TUBELITE®
STOREFRONT, CURTAINWALL & ENTRANCES
DEPENDABLE

Engineering Bulletin: **030701**

Subject: **Door Mid Rails**

E3255

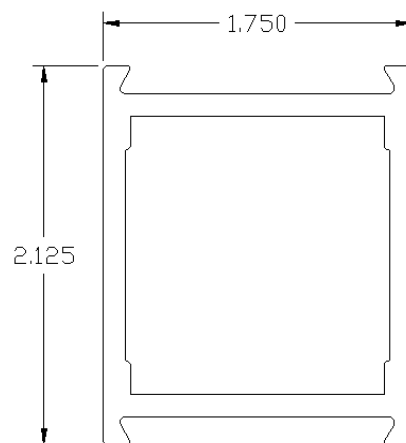
Description: On the above effective date there will be two new door mid rail extrusions available. These extrusions will have a double dovetail feature eliminating the need to use a door top rail with a muntin adaptor for 2 1/8" and 4" high mid rails.
